Ms. Anneke Davis, PE  
City of Kirkland Public Works Department  
April 13, 2018  
Page 9 of 11

<b>Key Excerpts from The Watershed Company's Compliance Review Letter</b>	<b>Response</b>
20	<p>Regardless of the condition of the existing buffer, the placement of a permanent structure within the buffer will preclude all future establishment of buffer functions, either naturally or through enhancement or restoration. In addition, the structure will be a central facility in the park, attracting more pedestrian traffic and use within close proximity of the stream and wetlands. The code standard in KZC 83.500.9.d.1.b should apply to portions of the proposed structure closer to the stream/wetland than the outer 25 percent of the buffer.</p>	<p>Practically speaking, the City's Parks Department is committed to maintaining Juanita Beach Park in its approved, permitted condition (lawn and playground). As such, establishment of buffer functions in that park area was going to be prevented, with or without placement of the relocated bathhouse. The buffer condition will actually be improved by the construction and planting of a native vegetated bioswale between the proposed building and the criti

Juanita Beach Park Property Kirkland, Washington	
<b>WETLAND BUFFER MITIGATION PLAN SHEET</b>	
April 2018	21-1-22161-006
SHANNON & WILSON, INC. <small>AN AFFILIATE OF THE SHANNON GROUP</small>	<b>FIG. 9</b> SHEET 1 OF 2

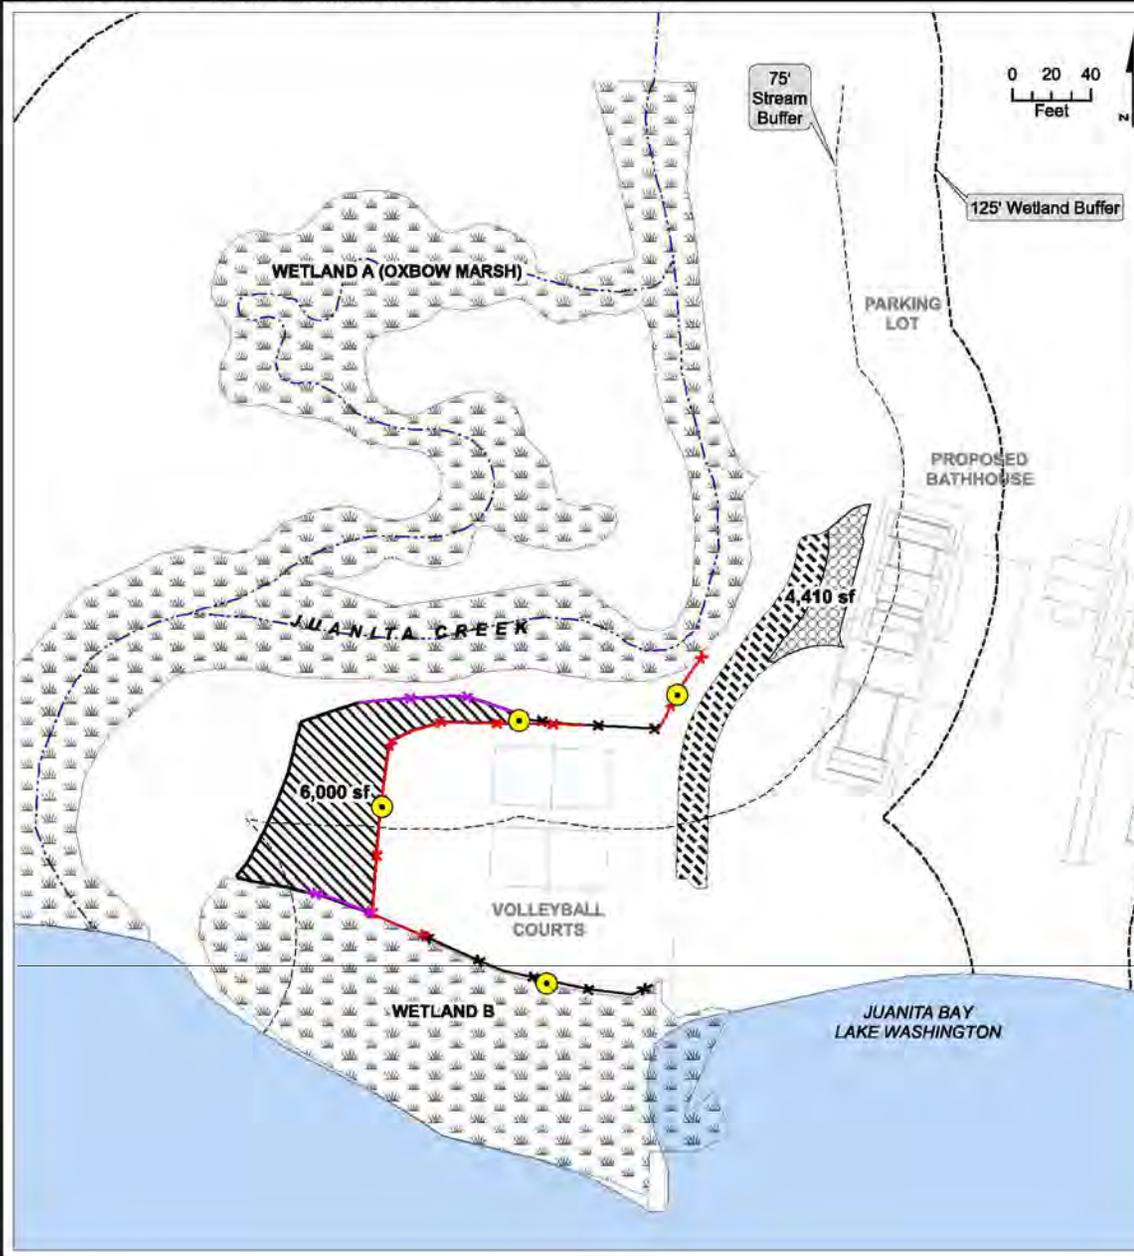
21	<p>In addition to split-rail fencing, critical areas signs should also be specified and noted in the plans. Given the proposed proximity of the active-use bathhouse to Juanita Creek and Wetland A, a split rail fence should be installed to demarcate the edge of the functional buffer and control access from active park users and pets.</p>	<p>A section of code in KZC 83 could not be located with a requirement for placement or spacing of critical areas signs. However, Figure 9 of the <i>Final Wetland /Stream Delineation Report and Mitigation Plan</i> has been revised to show proposed locations for four new critical area signs (see enclosed revised Figure 9, Sheet 1).</p> <p>The location and orientation of the proposed bathhouse and the vegetated bioswale together will help limit access into the narrow strip of functioning buffer fringing Juanita Creek/Wetland A. Activity in that area will be reduced by the proposed project with the installation of the vegetated bioswale and bathhouse where there is currently open lawn and a playground. Fencing this stretch of buffer was not required as part of Phase I, and the need for it will be even less after implementation of Phase II. Per Ecology suggestion, salmonberry, a thorny native shrub, has been incorporated into the plant schedule to act as a further deterrent to trespass.</p>

The species and densities of buffer planting appear to be generally appropriate. In addition to split-rail fencing, critical areas signs should also be specified and noted in the plans. Given the proposed proximity of the active-use bathhouse to Juanita Creek and Wetland A, a split rail fence should be installed to demarcate the edge of the functional buffer and control access from active park users and pets.

INSTALL WIRE FENCING AROUND EACH PLANT INSTALLATION, AROUND PLANTED CLUSTERS, OR AROUND THE WHOLE MITIGATION AREA WEST OF THE VOLLEYBALL COURTS TO PROTECT FROM BEAVER HERBIVORY. INSTALL SPLIT-RAIL FENCING AS SHOWN ON PLAN.

Critical Areas Signs
	JBPB - ARCH SITE New Pavillions
<b>Mitigation Fence</b>	
<b>Name</b>	
	Remove Existing Fence
	New Split-Rail Fence
	Existing Fence
<b>BUFFER MITIGATION</b>	
	Buffer Planting Area (See Shannon and Wilson Plant Schedule on Figure 9, Sheet 2)
	Wetter Area Native Mix (See MIG   SvR Plant Schedule on Figure 9, Sheet 2)
	Woodland Area Native Mix (See MIG   SvR Plant Schedule on Figure 9, Sheet 2)
